MEMORANDUM

DATE: June 9, 2016

SUBJECT: The Grove at Shoal Creek Planned Unit Development – C814-2015-0074 –
Update 2

Attachment(s)
Park Exhibit from PARD
E-mail to the Applicant by PARD staff

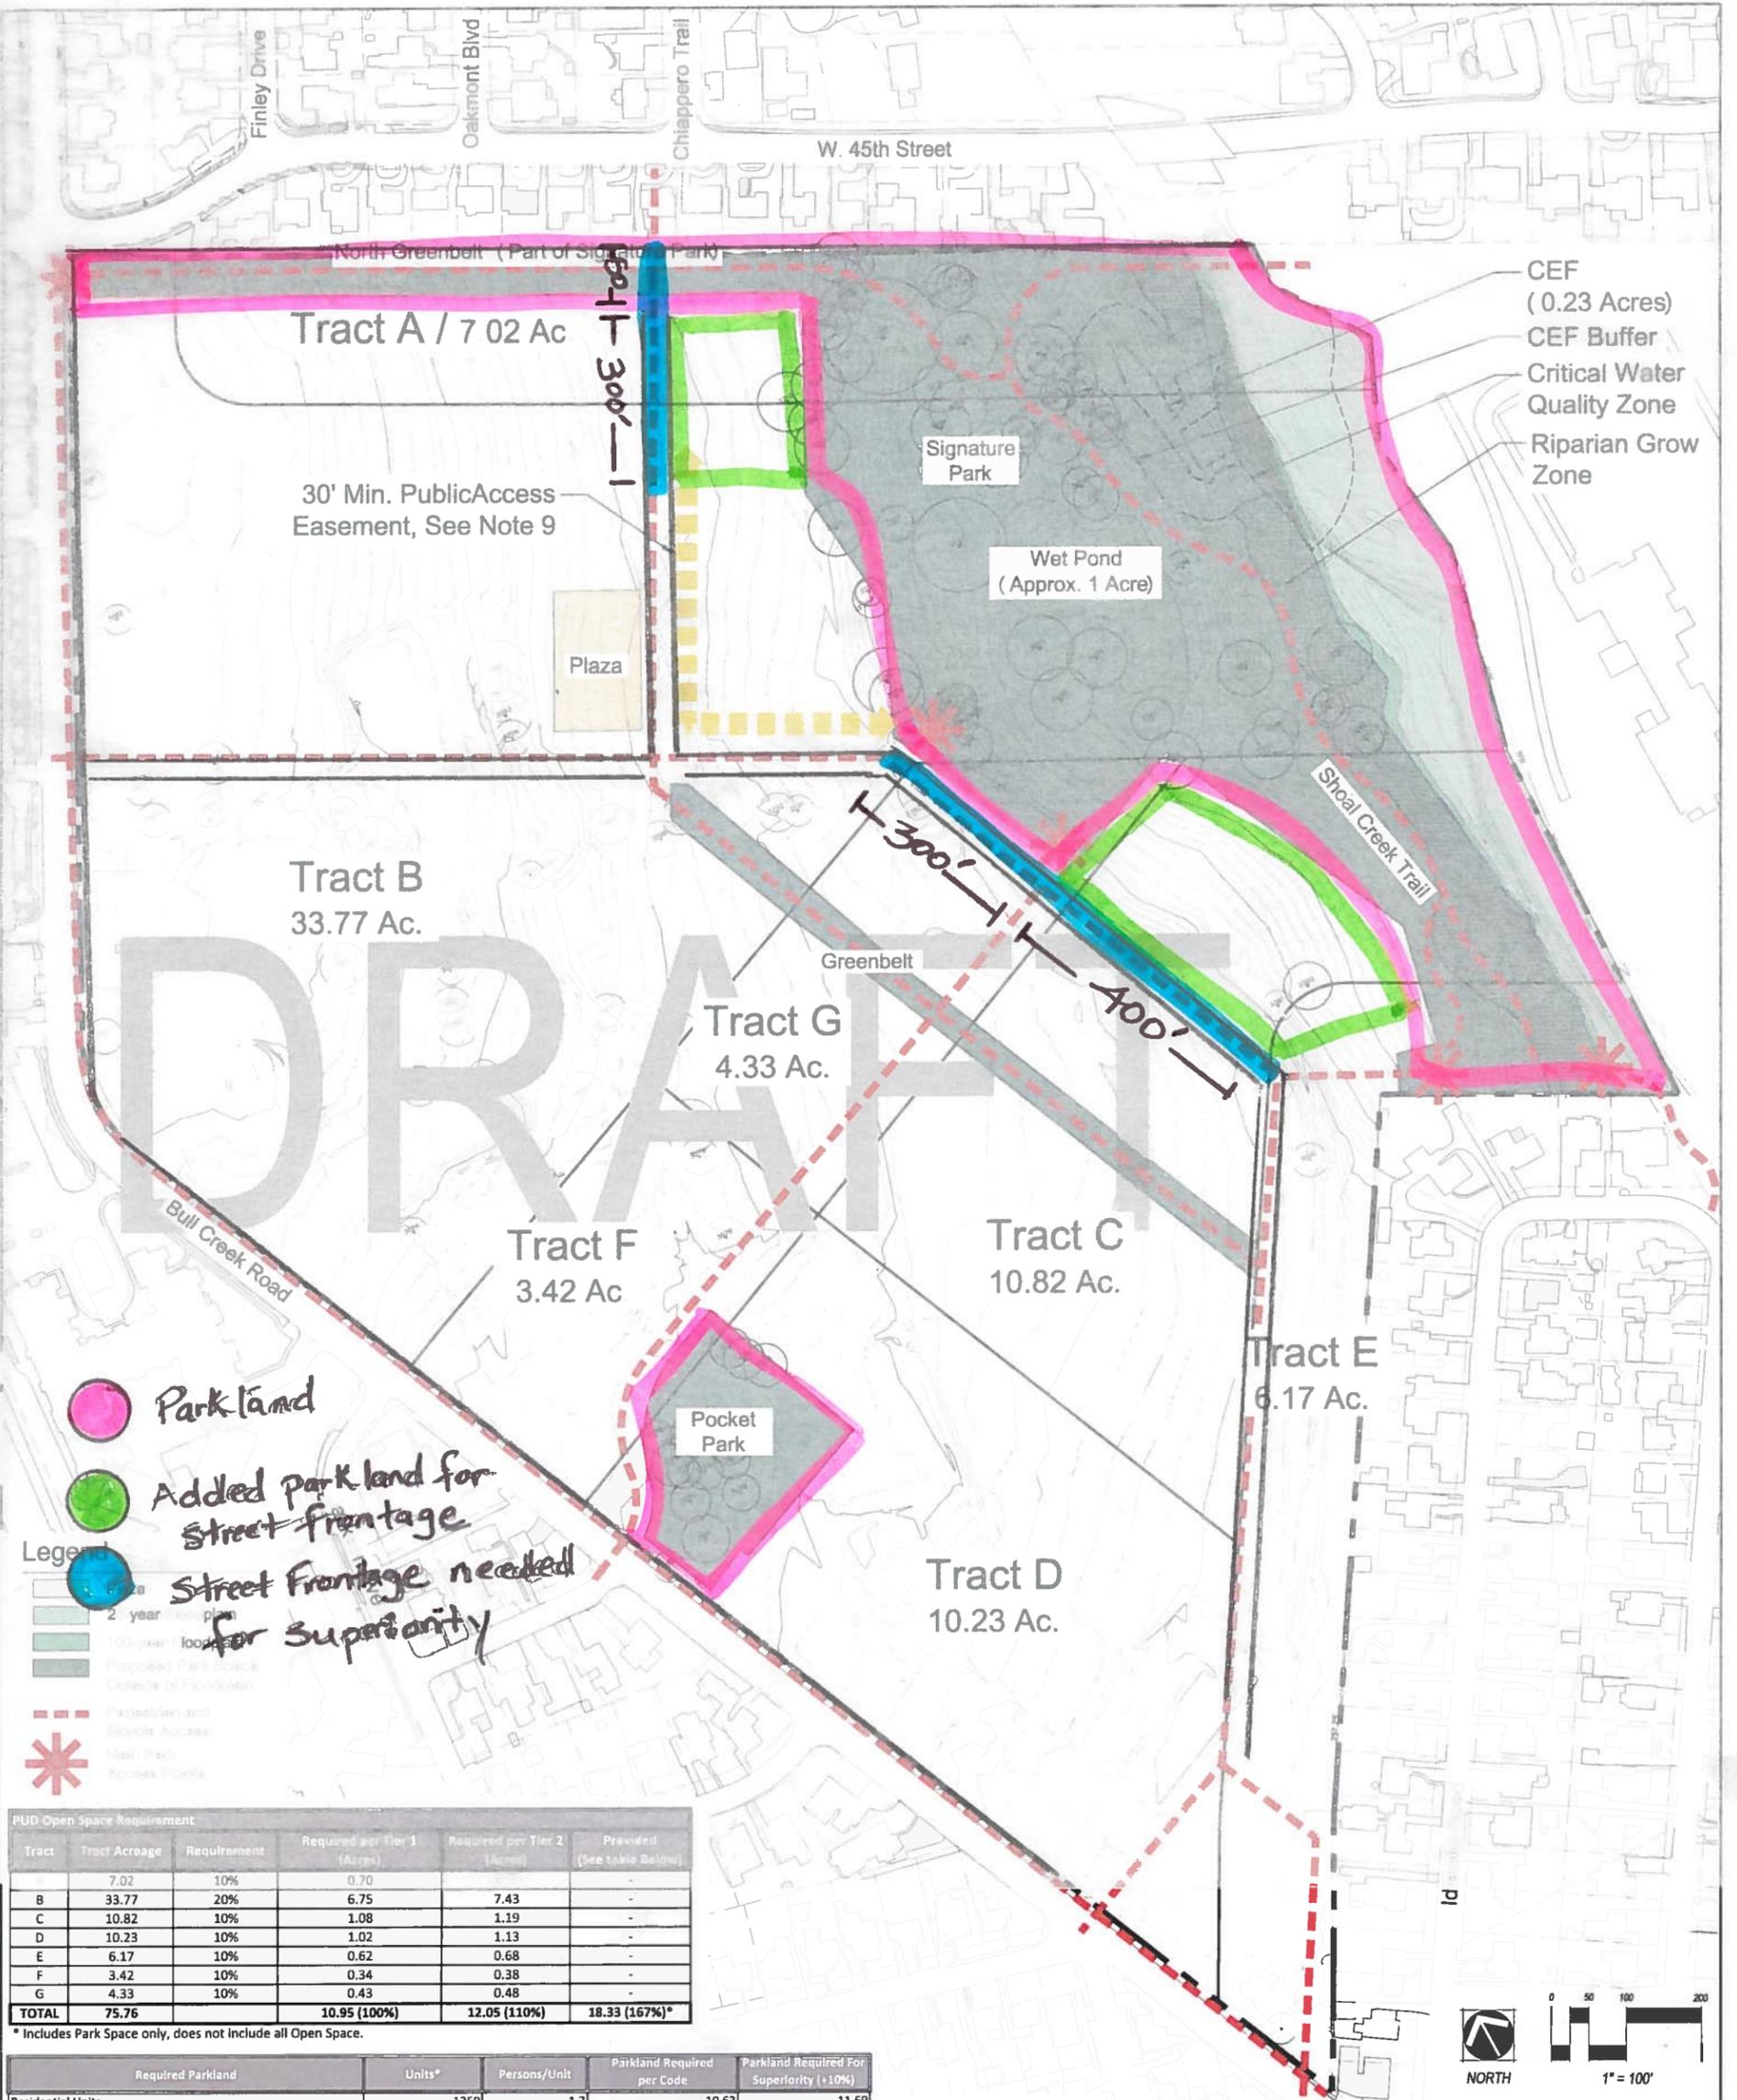
Jeff, Garrett, Robert and Ron, thanks for providing an updated exhibit and for placing the Flex Space into the Signature Park and removing the note related to Flex Space. Also, thanks for placing the label Pocket Park on the pocket park, please change the terminology in the table as well.

- The addition of 650 to 700 LF of frontage to the Signature Park for a total frontage of 1,050 to 1,100 LF of street frontage. (note the LF measurements shown on the attached are for reference and are NOT exact)

- The development along the frontage of most of the Signature Park will hide the park amenities, much as the playscape at Central Market and the Arboreteum cow sculptures are hidden from street view at those developments today. Those are not parkland. They provide an example of how we feel the Applicant's configuration will not address the public realm.

- Full credit was given to the grow zone (1.63 acres) due to its scenic value. However, in light of Watershed Protection Department's comments regarding some continued bank erosion, we are concerned that some portion of that acreage may not exist in future years. In light of this new information, PARD believes that some of this acreage must be recovered elsewhere in the Signature Park.

- As we explained at the Parks Board, much of the Signature Park acreage will have limited recreational uses, particularly if there is a requirement to increase the Critical Root Zone protection or if design requires the pond size to increase. This would could create a need to move the trail closer to the restaurant area.

- We need street frontage for superiority, regardless of how much acreage is owed. To this end, we would change Note 8 on the June 7, 2016 Park Exhibit that state: " the signature park should have a minimum of 400 feet of total street frontage" to " the signature park should have a minimum of 1,100 feet of total street frontage." Also see the attached graphic that extends the proposed park space outside of floodplain to show the street frontage.

- PARD does not agree with the public access easement in lieu of actual park street frontage. The yellow dashed arrows should be removed along with note #9.

The Grove PUD Erosion Assessment

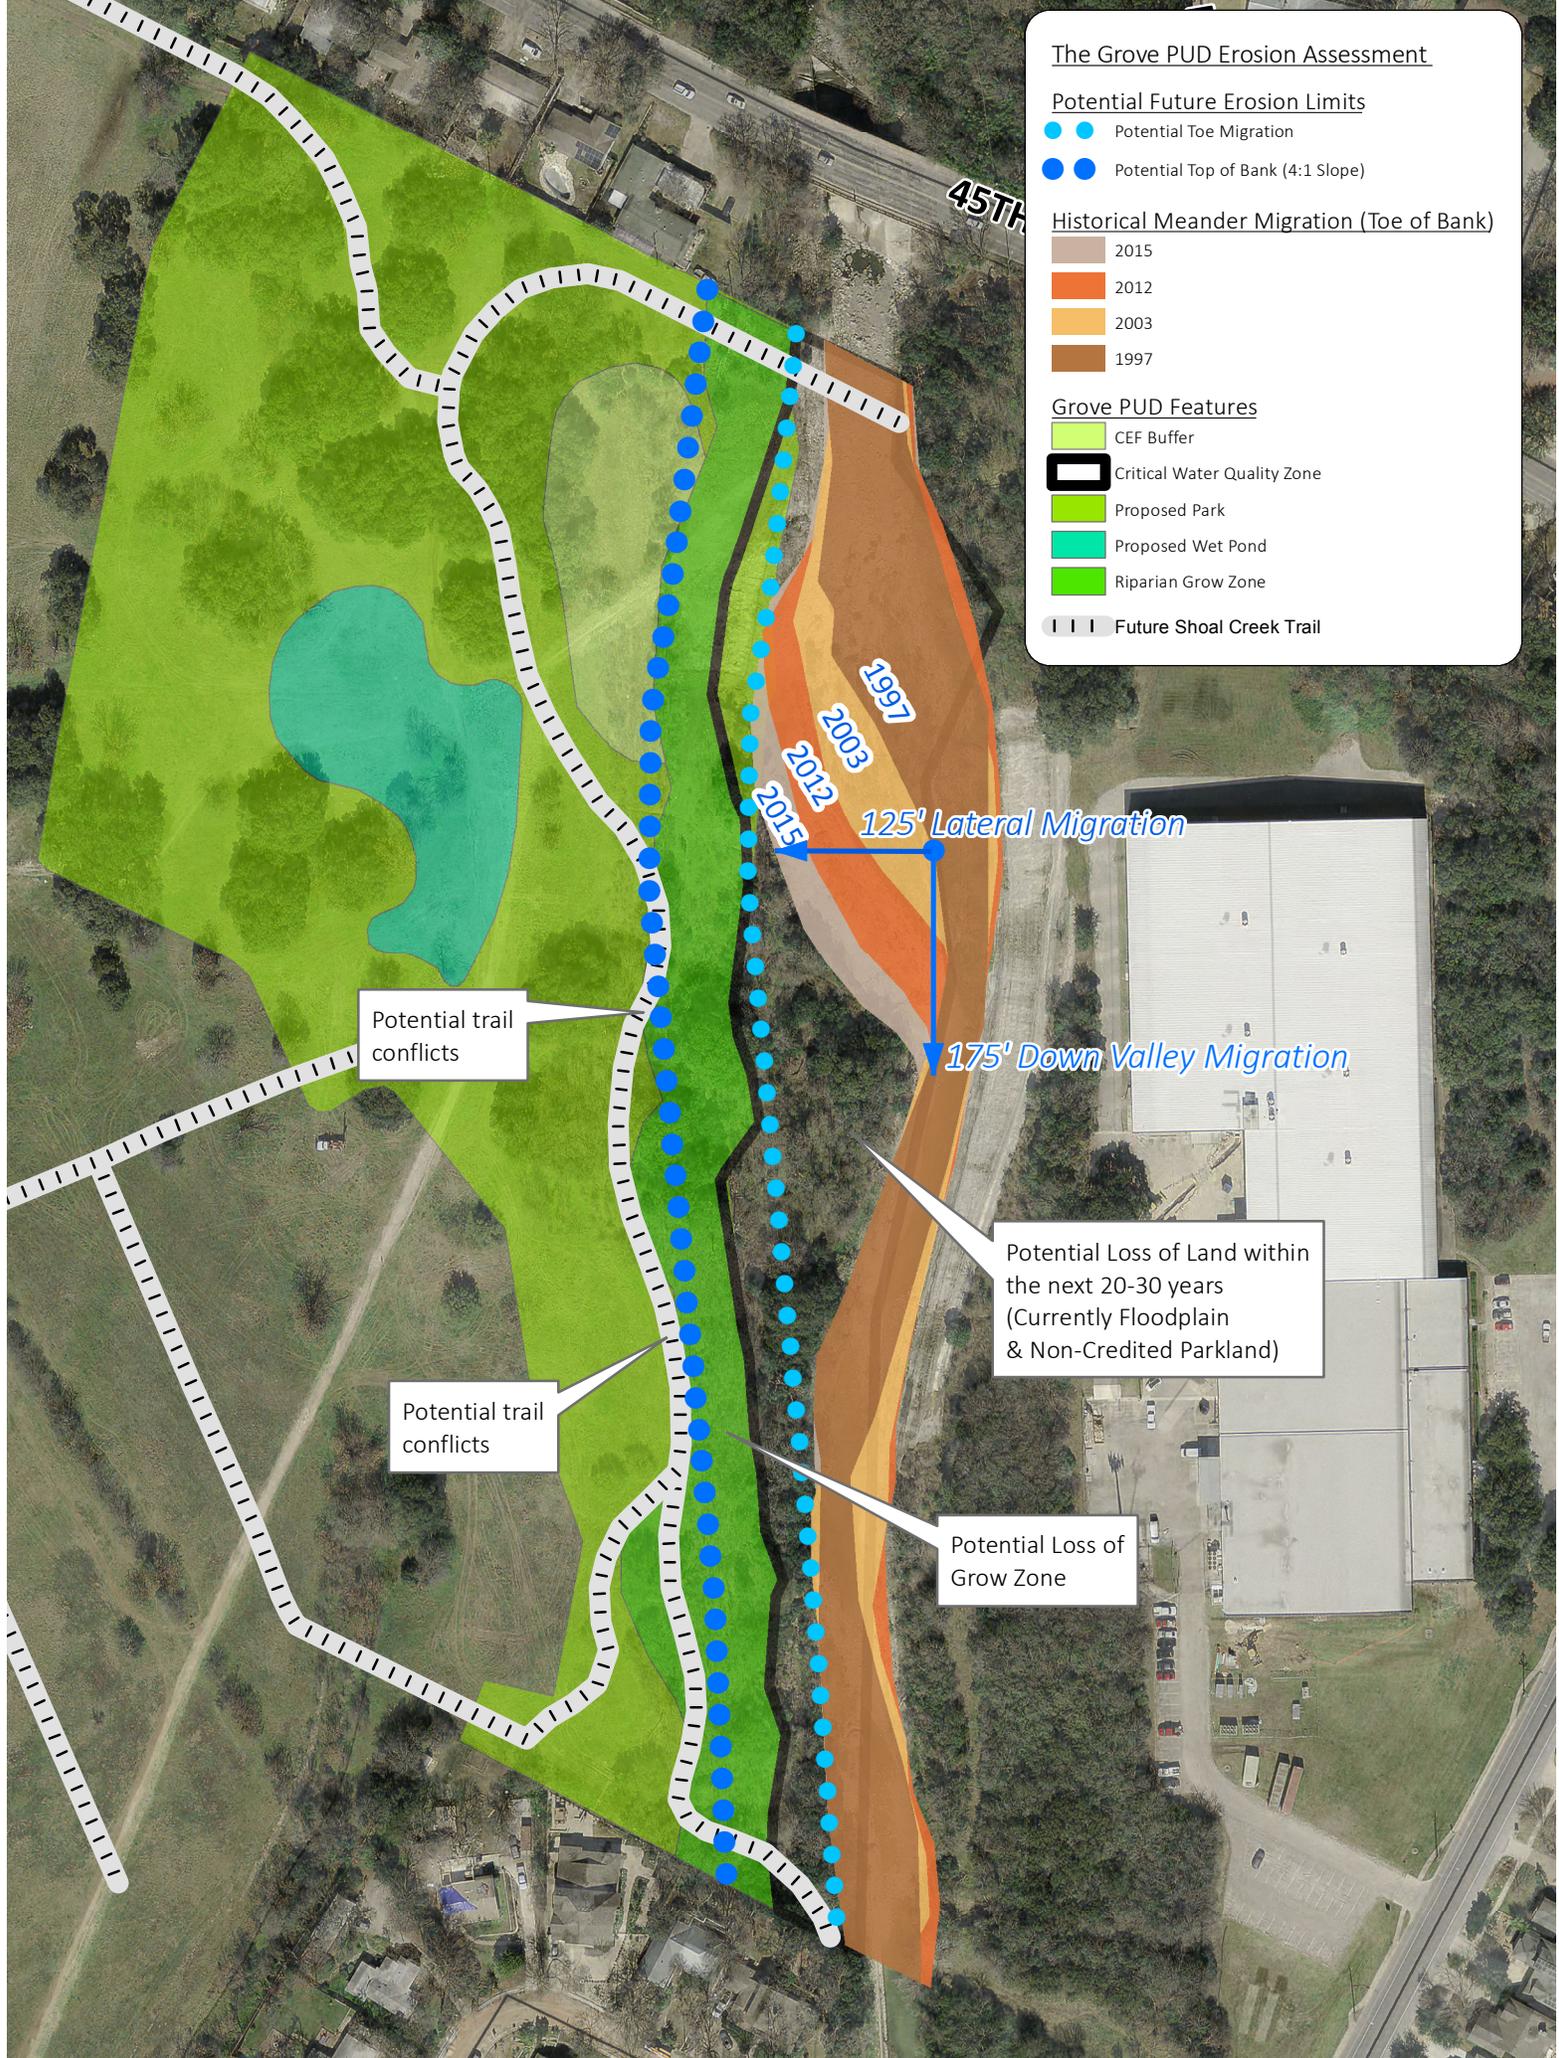
- Loss of land to the streambed is mostly confined to current floodplain, which is dedicated parkland, but not credited parkland
- Riparian Grow Zone will be mostly eroded as the bank stabilizes
- Potential future trail conflicts exist
- Wet pond outfall will need to avoid areas of future erosion
- The past erosion rate is ~10 feet/year. The future erosion rate is dependent upon storm events.

While it is difficult to precisely predict the evolution of urban streams that are highly impacted by the built environment, the erosion does show a consistent pattern of downstream migration – approximately 175' in 18 years. It is reasonable to assume that this pattern will continue as shown in the attached map, with the rate of movement dependent upon storm events. The downstream migration is expected to taper off as the stream reaches a pattern that mimics the historically stable downstream conditions. It is also reasonable to believe that the erosion will stabilize as the influence of the bridge hydraulics lessens further downstream.

The erosion has progressed 125' laterally at the worst point. It is reasonable to believe that the lateral erosion rate will slow or stop as the channel widens and the radius of curvature of the bend increases, moving the channel towards equilibrium.

Once the channel toe has adjusted, the banks will relax to a stable slope, assumed to be 4H:1V. This is a conservative assumption, with a sufficient factor of safety. Geotechnical borings and soil testing could refine this value. The banks are approximately 20', so the top of bank could be 80' from the toe based on the conservative assumption. However, depending on soil conditions, the top of bank could stabilize closer to the toe.

The attached map shows two blue dotted lines that show the predicted toe of slope (light blue) and top of bank (dark blue).
